Initial Statement of Proposed Rulemaking
Amendments to the Low-Emission Vehicle Program

Mobile Source Division
Monitoring and Laboratory Division
9528 Telstar Ave.
El Monte, California 91731

Date of Release: September 25, 1992

FIGURE 3. TEST PROCEDURE FOR HYBRID ELECTRIC VEHICLES

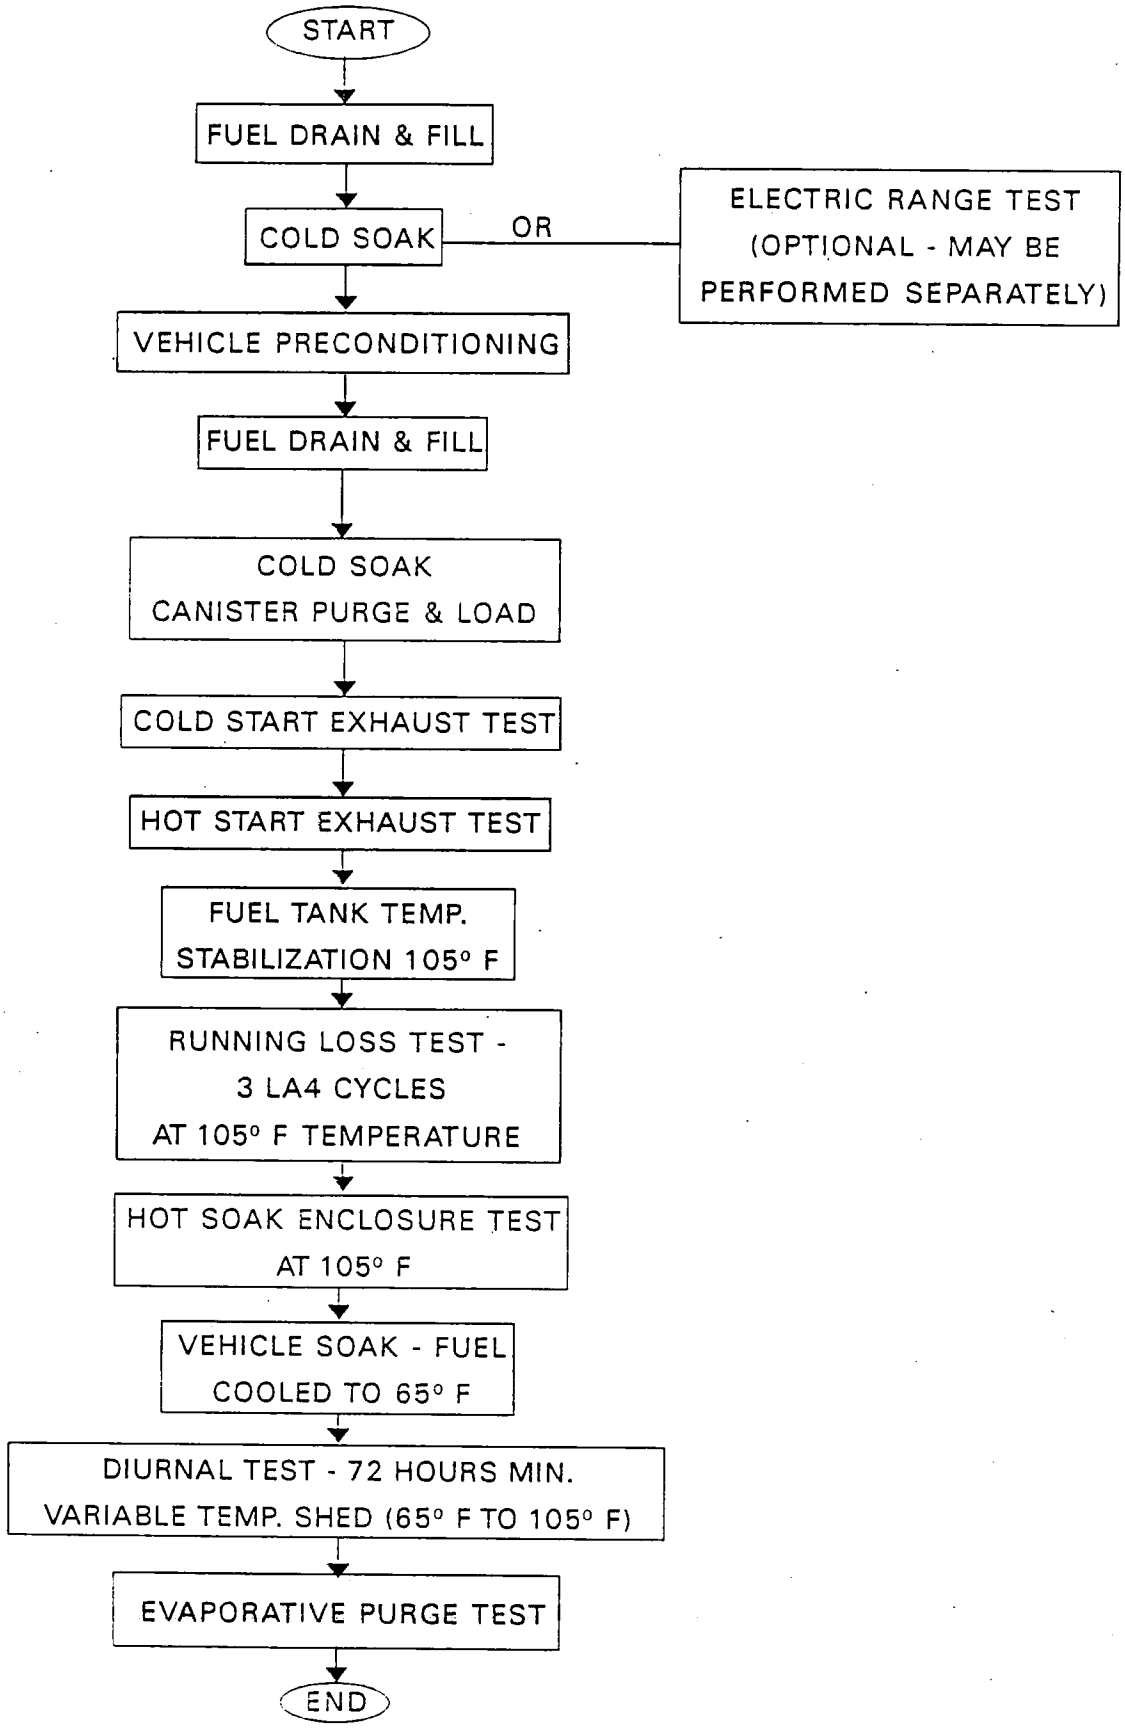
The test sequence shown in Figure ~~1~~2 (Figure 3 for hybrid electric vehicles) describes the steps encountered as the vehicle undergoes the procedures to determine conformity with the standards set forth. During the exhaust portion of the test procedure, i.e., from "START" to the completion of the "HOT START EXHAUST TEST," ambient temperature levels encountered by the test vehicle shall not be less than 68°F nor more than 86°F. The temperatures monitored during testing shall be representative of those experienced by the test vehicle. The test vehicle shall be approximately level during all phases of the test sequence to prevent abnormal fuel distribution. The test sequence shown in Figure ~~1~~2 (and Figure 3 for hybrid electric vehicles) is briefly described as follows:
